To Northern Pass Transmission LLC, the New Hampshire Department of Transportation, the New Hampshire Division of Historical Resources and the New Hampshire Site Evaluation Committee.

Northern Pass proposes a work area for Horizontal Directional Drilling that appears to encroach on our property (the Joyce C. Thoma Trust) on Route 116 in Easton. Since the diagrams do not show property lines, this cannot be determined. The diagrams also do not indicate the width claimed for trenching.

HDD 020 ENTRY AREA WORK SPACE

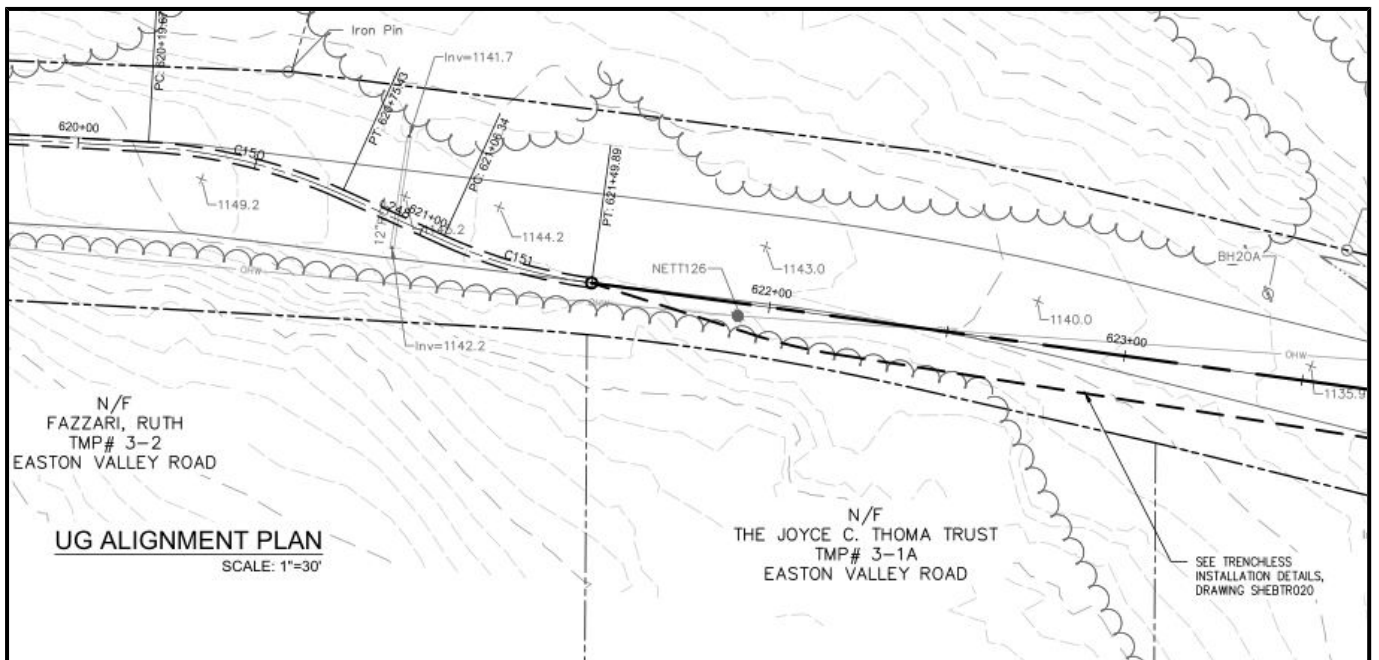
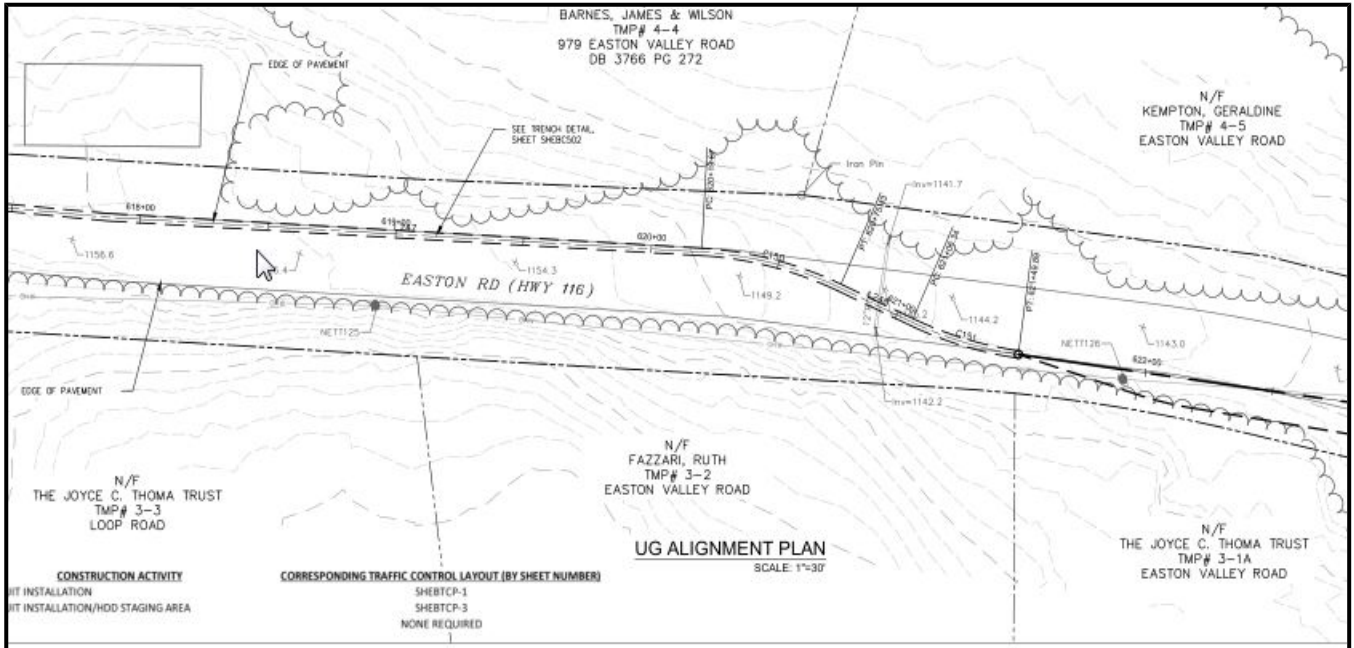
Regardless, NPT claims an easement width of 66', but this section of 116 is at most 3 rods wide (49.5') and possibly 40'. For this reason the claimed 66' easement encompasses portions the foundation of the former Young's Store, which can not be disturbed. NPT was notified of the road width issue during the course of the PUC docket DE-15-460 but has made no effort to address it and has provided no support for the easement widths it has continued to draw on its diagrams. The HDD work area diagram below has a scale, unlike those that follow, but we assume the claimed easement width is the same throughout.

If the very vague dotted line below and right of the name "Barnes, James and Wilson" indicates the tree line, then the property boundary between the Thoma property and the Fazzari property lies directly below the upper "HDD entry" as seen below:

Trepass will not be allowed, and we request that the applicant provide documentation of their claimed easement width and accurate diagrams.
